Sub: Modification Sheet No. RDSO/2022/EL/MS/0488 (Rev. '0') dtd. 22.07.2022 for provision of Blocking Diode in HOG control circuit (in series of MCB 129.2/1) of HOG compliant WAP7 & WAP5 Three Phase Electric Locomotives.

MODIFICATION SHEET NO. RDSO/2022/EL/MS/0488 (REV. '0') dated 22/07/2022

Provision of Blocking Diode in HOG control circuit (in series of MCB 129.2/1) of HOG compliant WAP7&WAP5 Three Phase Electric Locomotives.

6.0 Modified Scheme:

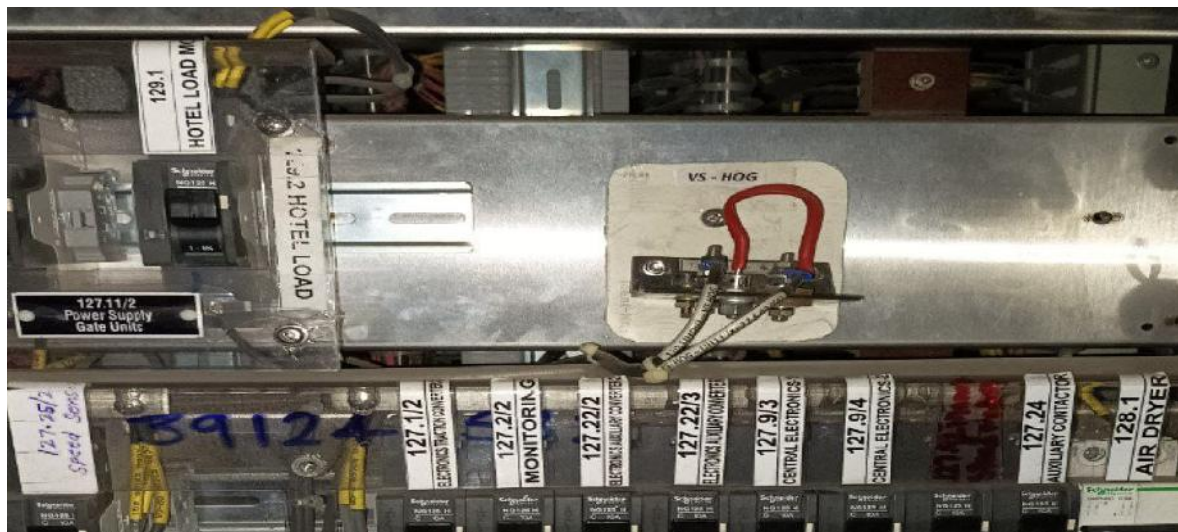
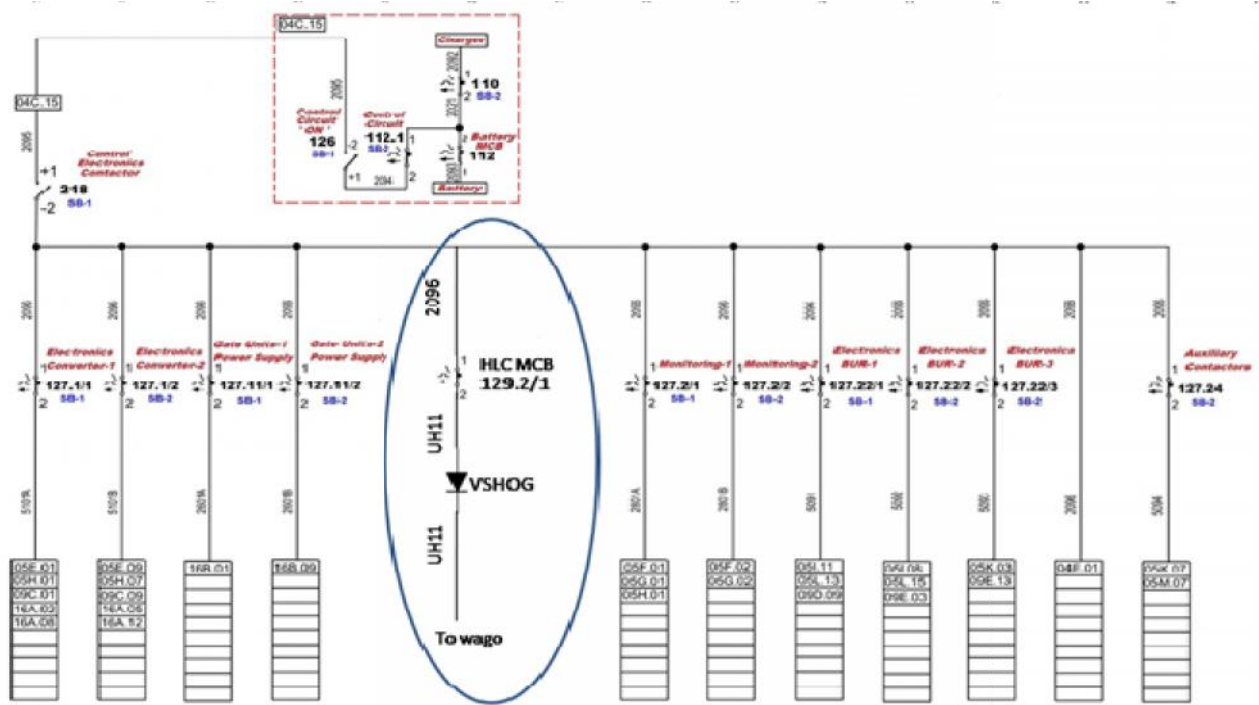
- 3.1** To avoid above failure, a diode has to be placed in HOG control supply path after MCB (129.2/1), which blocks the reverse feed from UIC coupler at Pin 11. Same modification is implemented in 37538/LGD locomotive and verified that locomotive is working normal even though wrong feed is given in UIC coupler (pin 11) and ELS/ED has also reported that to avoid back feed from power car, a blocking diode (VSHOG) has been provided in all ELS/ED locomotives and working satisfactory.
- 3.2** As a result, HOG, SR, BUR, VCU electronics can be switched OFF since contactor 218 will remain open and false feedback from power car through UIC coupler pin no. 11 will not go to control electronics after addition of blocking diode.
- 3.3** The main objective of this modification sheet to suggest a scheme to avoid failure of locomotives due to wrong feed from power car through UIC coupler pin no. 11.

- 4.4** However, in case, false feedback from power car appears then even if battery MCB 112.1 is OFF and contactor no. 126 is open, contactor 218 will remain open. Wire no. 2096 will have supply due to false feedback of 110 V DC from power car through hotel load MCB 129.2/1 due to which HOG, BUR, SR and VCU electronics will not get switch off. They will get supply directly from false feedback via wire no. 2096, since 110 V DC supply is available on pin no 11 of UIC socket which is coming from power car.

SN	Instruction
1	Insert a diode (labelled as 'VSHOG') in series with the cable no. UH11 of 129.2/1 MCB output in SB2. (Remove the cable no. UH11 from wago in SB2 and connect it to diode anode terminal, connect cathode terminal to wago in SB2).
2	Secure the diode to protect it from getting earthed or opened due to vibration.
3	After completion of work, ensure the following two aspects a. Ensure correct polarity of diode provided by observing the status of HLC converters display (display should be 'ON') after keeping BL switch in 'D' position. If display is blank, then diode polarity shall be corrected. b. After MCE ON, extend 110V feed to UIC coupler pin no. 11 from self-locomotive battery positive cable. Now try to switch 'OFF' MCE and ensure that MCE is getting 'OFF' and again carry out MCE ON and it should be possible to reach 504 node (power ON). If any deviation in the above mentioned behavior, ensure correct wiring of modified circuit.

MCB 129.2/1 Modified circuit diagram is given below.
